**AGENDA  
CITY OF CEDAR FALLS, IOWA  
PLANNING AND ZONING COMMISSION MEETING  
WEDNESDAY, OCTOBER 13, 2021  
5:30 PM AT CITY HALL AND VIA VIDEO CONFERENCE**

**TO:** Planning & Zoning Commission  
**FROM:** Chris Sevy, Planner I  
**DATE:** October 6, 2021  
**SUBJECT:** Greenhill Village Car Wash at 1125 Fountains Way

**Greenhill Village Car Wash  
Site Plan Review  
1125 Fountains Way (SP21-012)**

**TO:** Planning and Zoning Commission  
**FROM:** Michelle Pezley, Planner III  
Luke Andreasen, PE, Principal Engineer  
**DATE:** September 30, 2021  
**SUBJECT:** PP21-003 West Fork Crossing Preliminary Plat

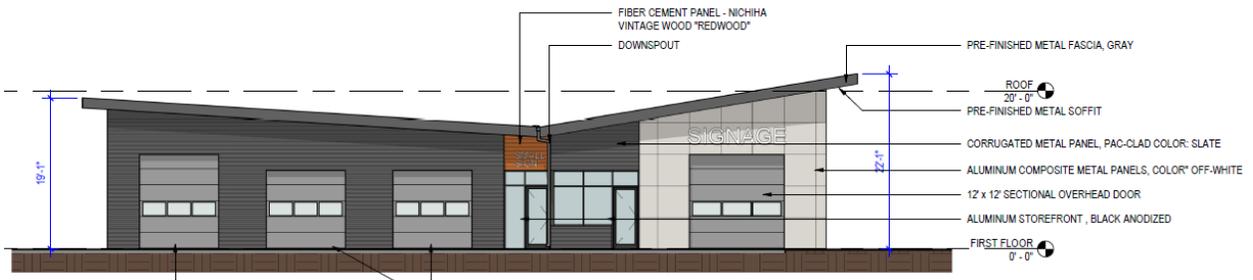
- 5) Building Design: The MU District requires a design review of various elements to ensure architectural compatibility to surrounding structures. These are noted below with a review on how each element is addressed.

The proposed building has a contemporary industrial design with an overall height that is similar to other adjacent buildings. The slanted roofs and corrugated metal paneling would be relatively unique features in this neighborhood but they appear to complement the industrial

look that the applicant is aiming for. Of particular note are the significant window openings along the front façade that provide views into the interior of the car wash. This provides a unique design for a car wash, which more typically has blank walls with few window openings. Also, the colors and pattern of the design alternate sufficiently to provide visually interesting facades.

- 8) Signage: There is signage implied by the renderings, however no official details have been provided by the applicant. Renderings show signage on all four elevations but will only be allowed on two wall surfaces. Signage will be required to be reviewed by the Planning and Zoning Commission and City Council when an official signage application is received.

SITE DEVELOPMENT PLAN

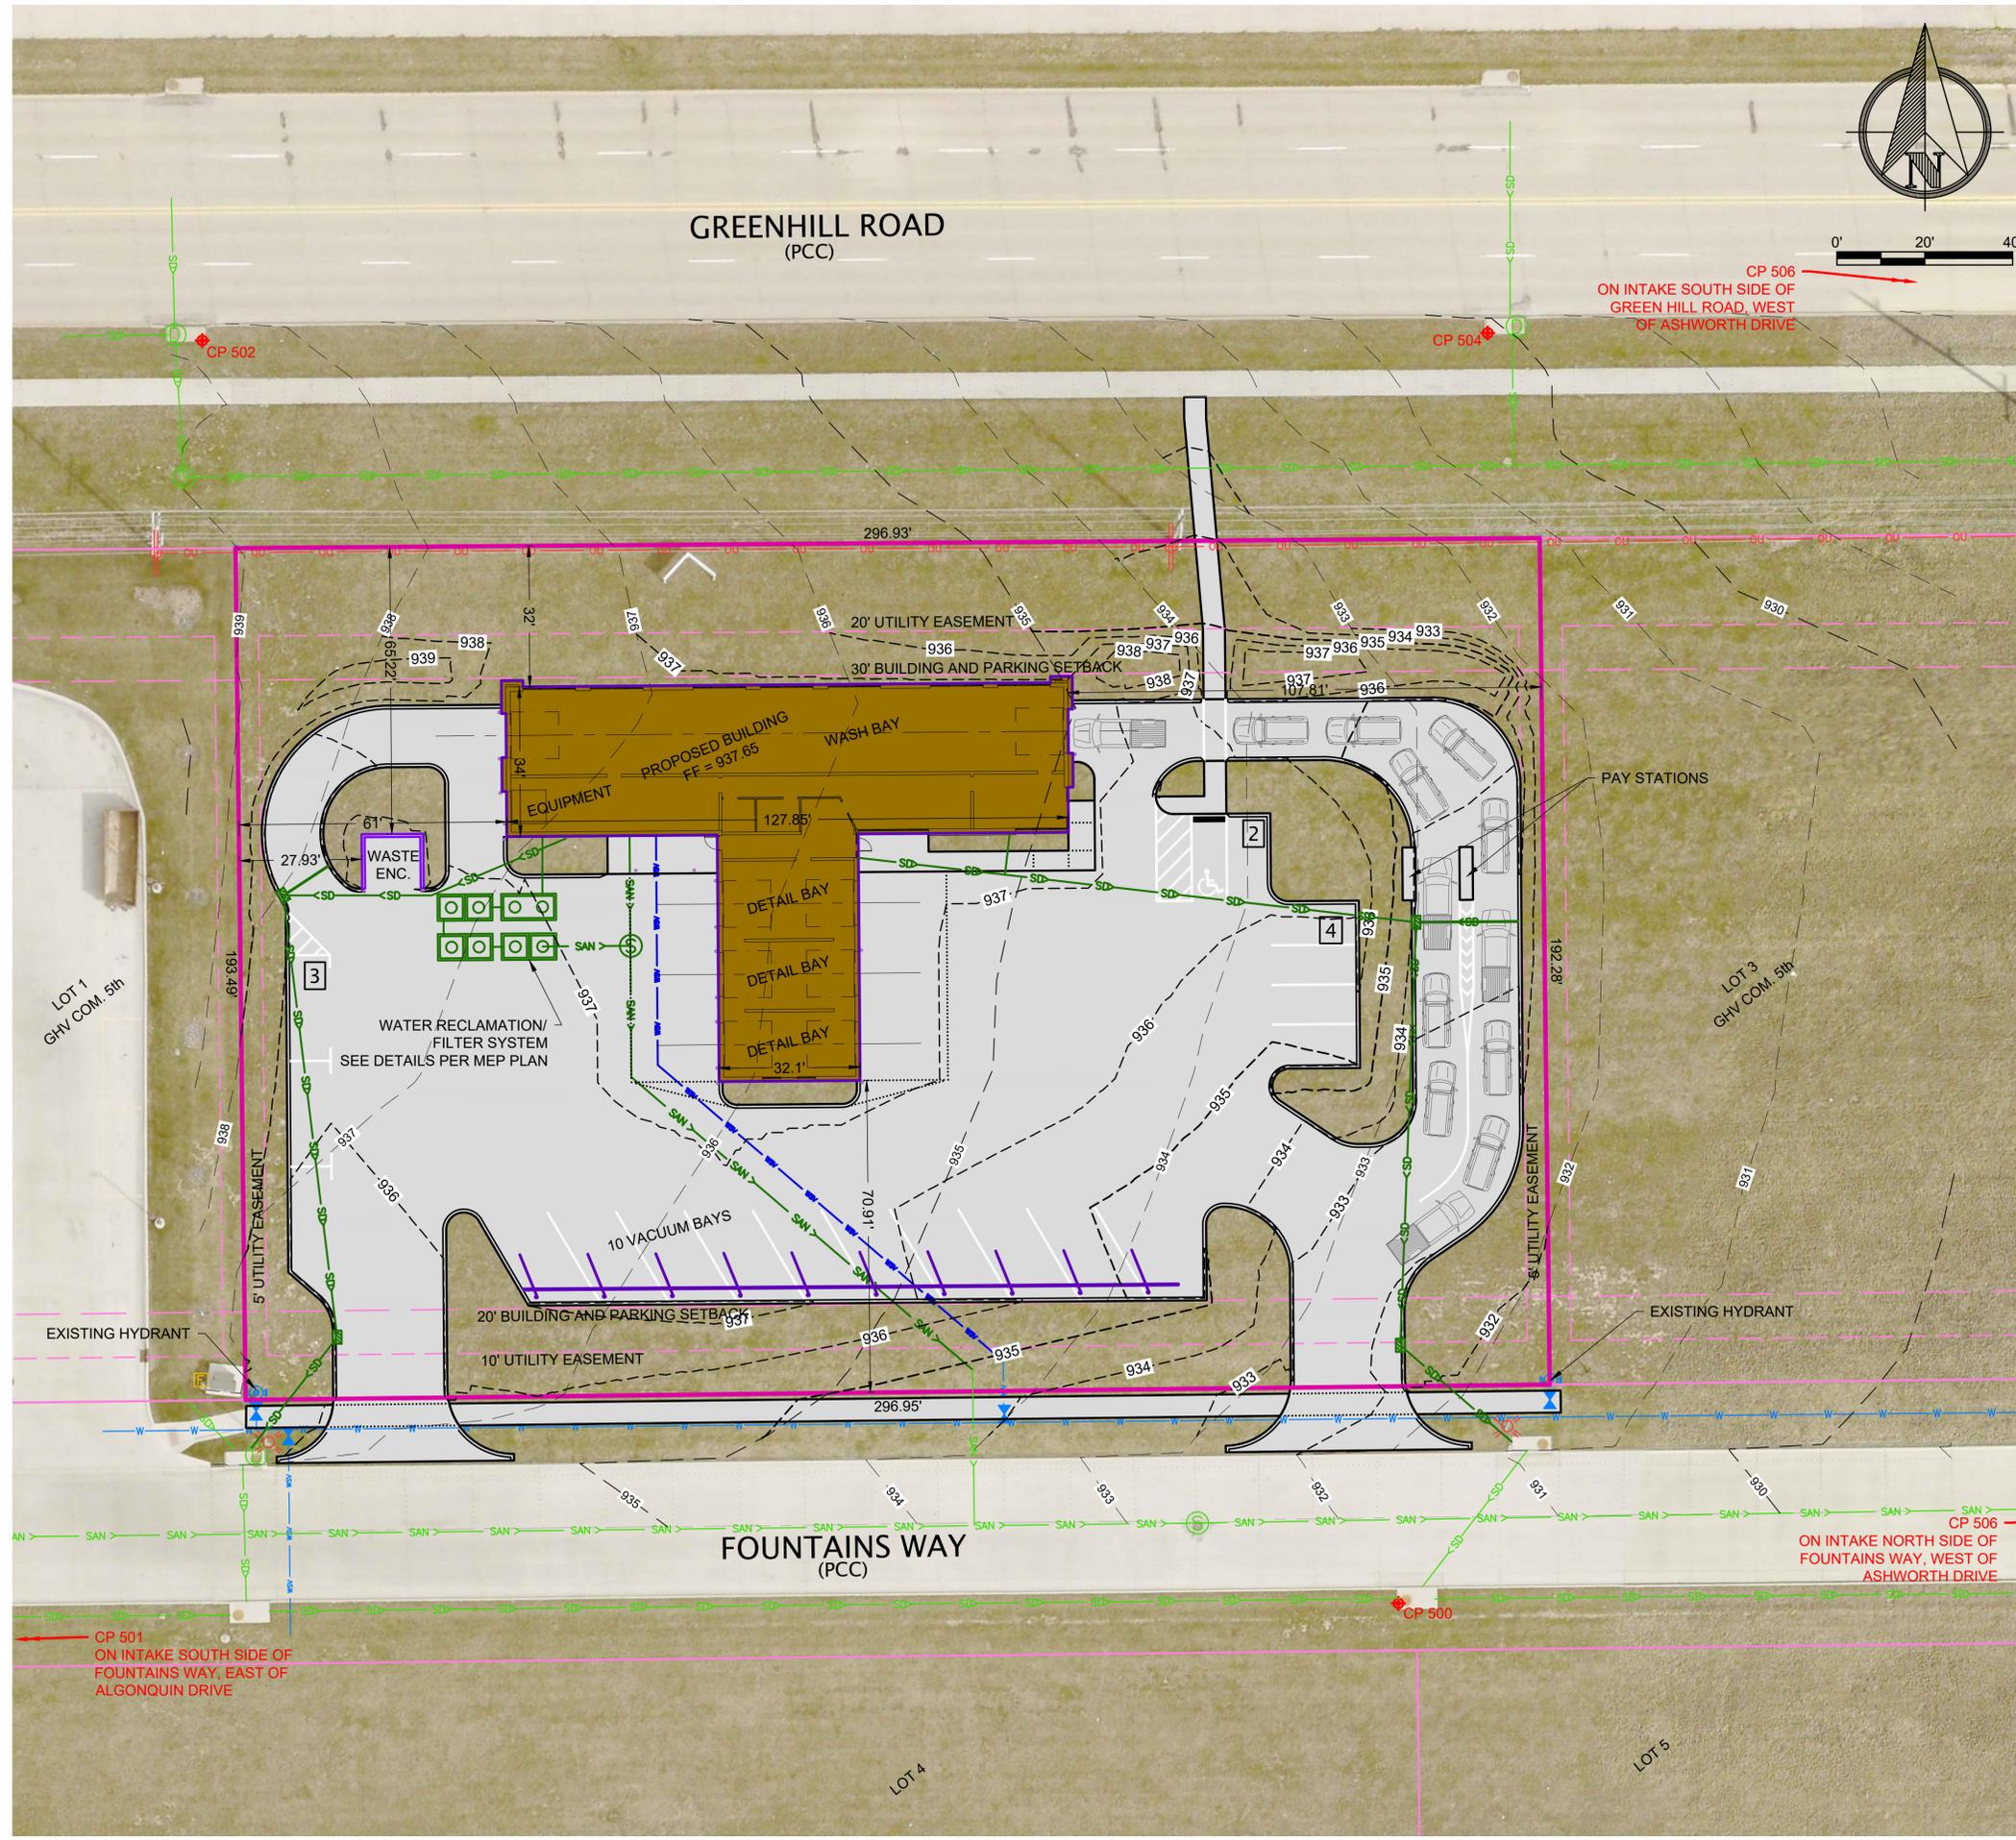
- 2) Building Location: The setbacks for this district are 30 feet along Greenhill Road and 20 feet along Fountains Way. All buildings and parking areas must be located outside these setback areas. The site plan indicates that the building and parking areas are 30 feet from Greenhill Road, 20 feet from Fountains Way. The parking areas are also 5 feet from both the east and west property lines (the minimum as per the parking code). **Building and parking setbacks are satisfied.**

- 3) Parking: The parking requirement for the proposed car wash is one stall for every two employees. They anticipate 6 employees which brings the requirement to 3. The applicant is proposing 9 parking stalls in addition to 10 vacuum bays that are also being provided. **The parking requirement is satisfied.**

1 DUMPSTER LOCATION  
1/8" = 1'-0"

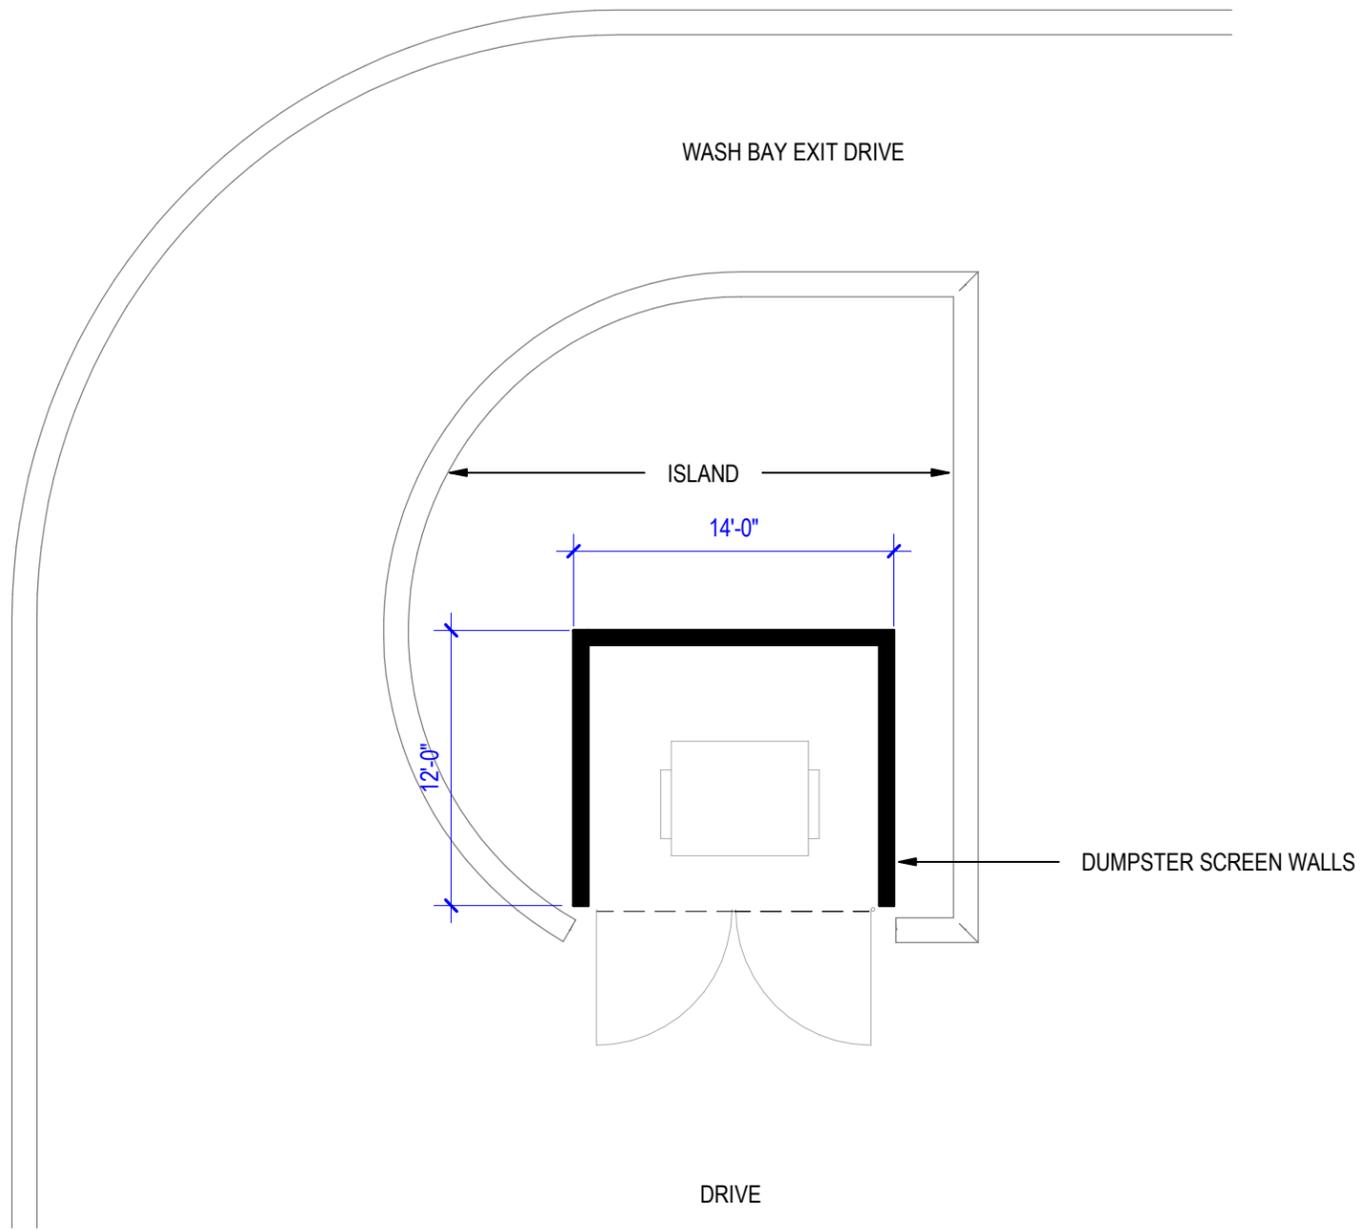
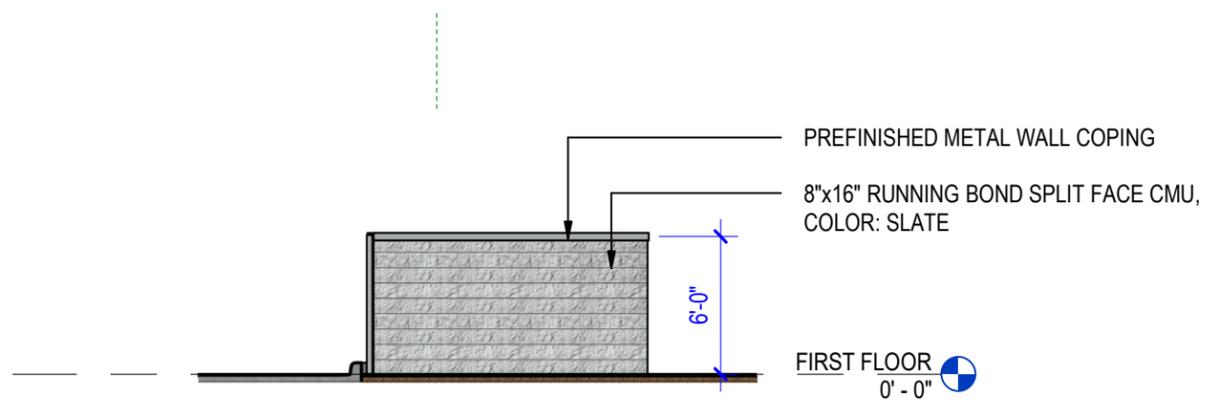
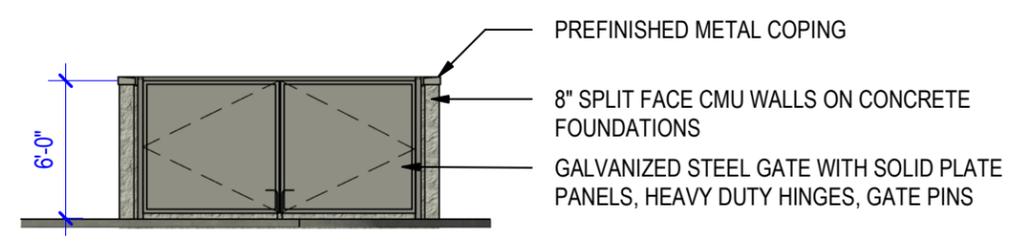
- 6) Trash Dumpster Site: There is a dumpster enclosure in the northwest corner of the site. The enclosure wall is made up of 8" by 16" running bond split face CMU that is of the same color as the corrugated metal material on the building. It also has a galvanized steel gate and prefinished metal coping. The dumpster walls are 6 feet tall with landscaping around three sides. **The dumpster location and design provide adequate screening from the public views.**

### LANDSCAPE PLAN GREENHILL CARWASH

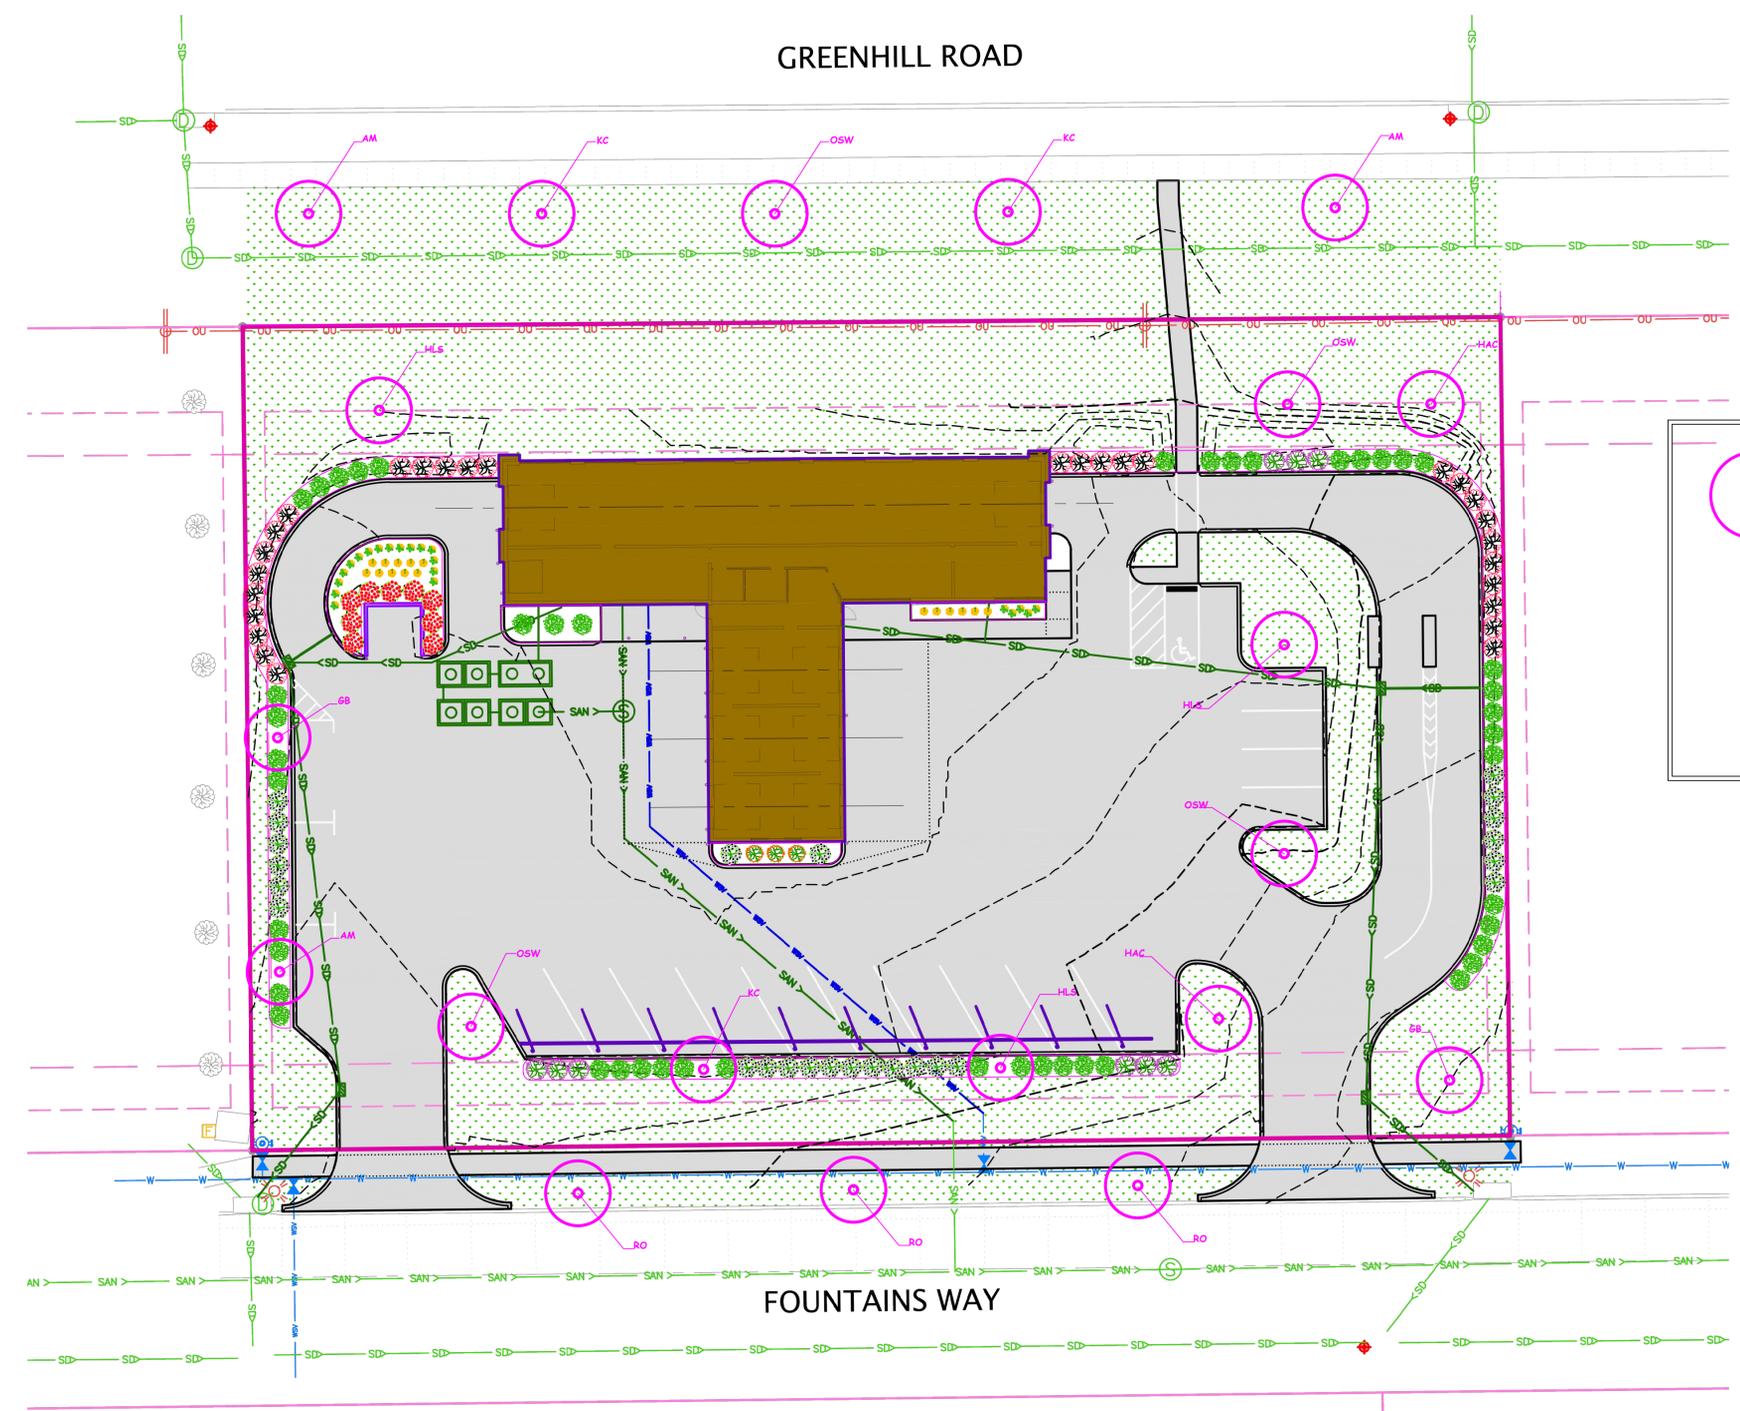
- 4) Open Green Space/Landscaping: The MU District requires that open green space be provided at the rate of 10% of the total development site area excluding the perimeter setback along Greenhill Road. The development site is 57,274 square feet of land. Exclusive of the setback areas, the open space provided on this is approximately 7,689 square feet or 13.5% of the land. Below is the proposed landscape plan:

The open green space, site plantings, street trees, and general trees meet the minimum requirements and are well distributed. The landscape includes a mixture of trees, shrubs, and berm elements distributed throughout the site and around the building. **The landscaping plan is satisfied.**
